| Document Title: | AHRI Comment - Proposal - Title 20 II Pre-Rulemaking - Commercial and Industrial Fans & Blowers |

Re: AHRI Proposal – Title 20 Phase II Pre-Rulemaking – Commercial and Industrial Fans & Blowers *[Docket No. 17-AAER-06]*

Proposal Information Template – Commercial and Industrial Fans and Blowers

Air-Conditioning, Heating, and Refrigeration Institute, September 18, 2017

Figure 1: Condenser Fan Operating Characteristics

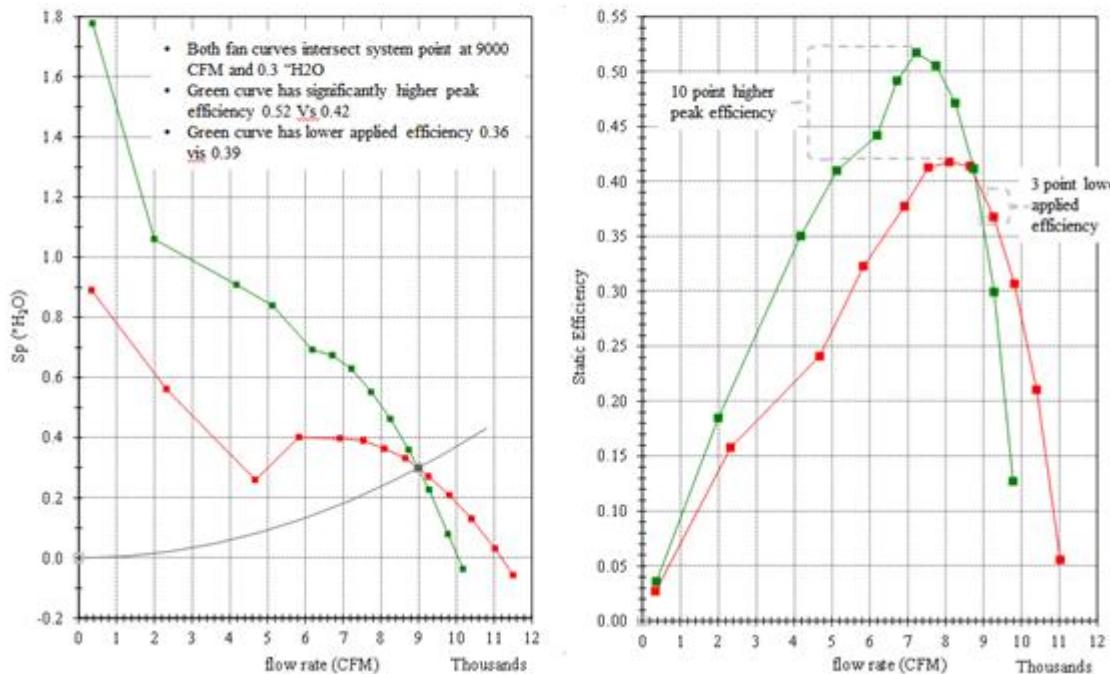
Further, a “more efficient” fan may not yield a more efficient unit if the fan curve performance does not meet the likely operating conditions. In a specific example, there may be a “higher efficiency” fan that does not work as well as the lower efficiency fan in a specific condenser fan application because of where the fan actually operates. In this case, the red fan offers better performance relative to the green fan, even though the green fan has a peak efficiency well above the red one. The fan operates based on flowrate and static pressure and, in this case, the red fan is the better fan. This is a very specific example that indicates the designer needs to be extremely careful in applying Embedded Fans into a product (Figure 1).

As a result, the energy savings from a fan component standard on embedded panel fans in air-cooled chillers is likely to be very close to zero both for individual building owners and for California in total.

Figure 2: Reported US Shipments of Central Station Air-handling Units

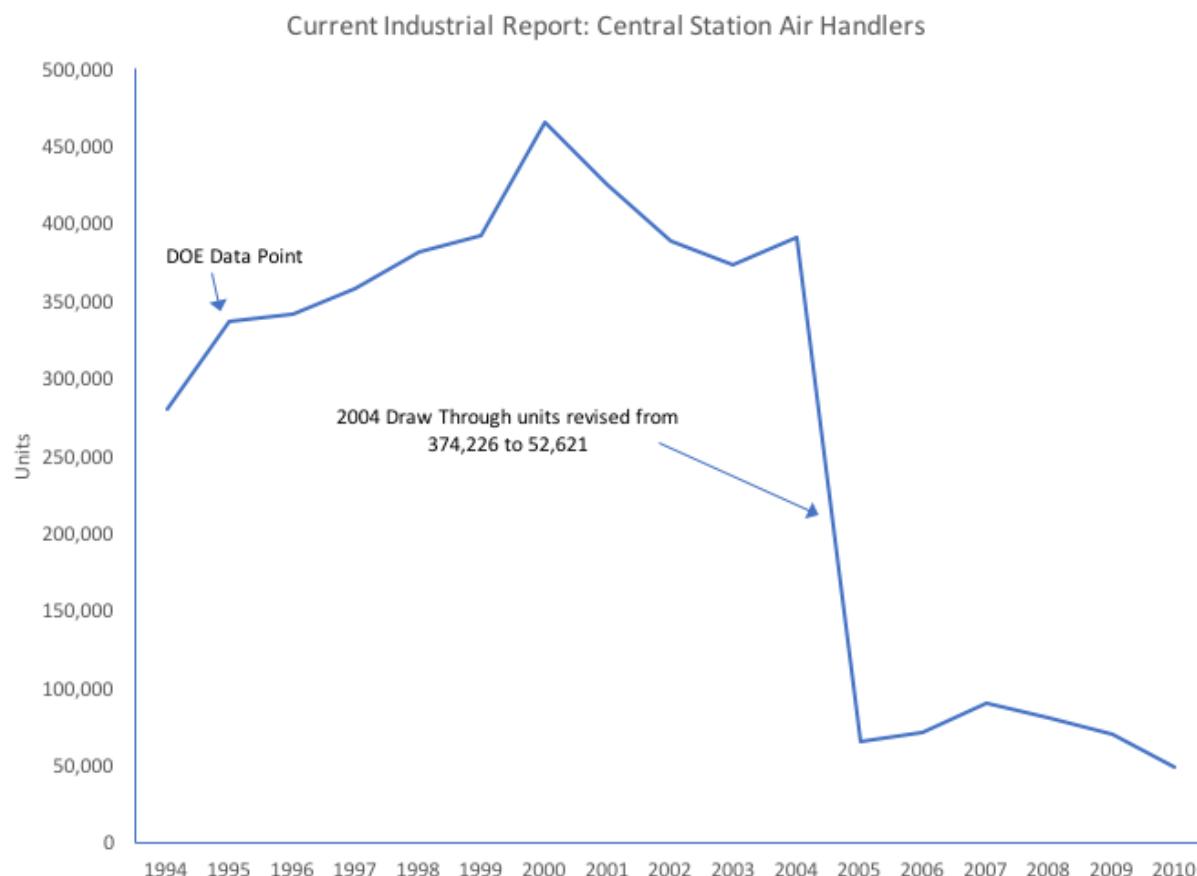
The major reason for the dramatic drop in savings from central station air-handling units is that DOE used old, incorrect data to project the number of central station air-handling units shipped. DOE included in its analysis an estimate that there are 330,402 central station air-handling units shipped.¹³ This is based on an Arthur D. Little study (Opportunities for Energy Savings in the Residential and Commercial Sectors with High-Efficiency Electric Motors. December 1999. Prepared for the US Department of Energy by Arthur D. Little, Inc.) which, in turn, relied on data from the US Department of Commerce, Census Bureau, Current Industrial Reports MA35M (CIR) for 1995. Arthur D. Little correctly used the data presented at that time in the CIR. However, there seems to have been a reporting error for product code 35851-13 central station air-handling units (motor driven fan type) – draw through, reported as 315,723 units in 1995, the year referenced by Arthur D. Little. This product category was revised for 2004 and subsequent years in the CIR for 2005, with 2004 shipments for that product code (now 3334151117) reduced from 374,226 to 52,621. The shipments for total central station air-handling units remained in the range of 48,000 to 90,000 units until 2015, when the CIRs were discontinued (Figure 2). AHRI collects but does not make public shipment data for central station air-handling units and the AHRI data is consistent with shipments in the high tens of thousands of units per year.

AHRI data shows a decline in central station air handling units from a peak in 2007 through 2016. Based on the declining trend in shipments and the average of shipments in the CIR from 2004 through 2015, a reasonable estimate of future central station air-handling unit shipments would be approximately 65,000 units per year, nationally.
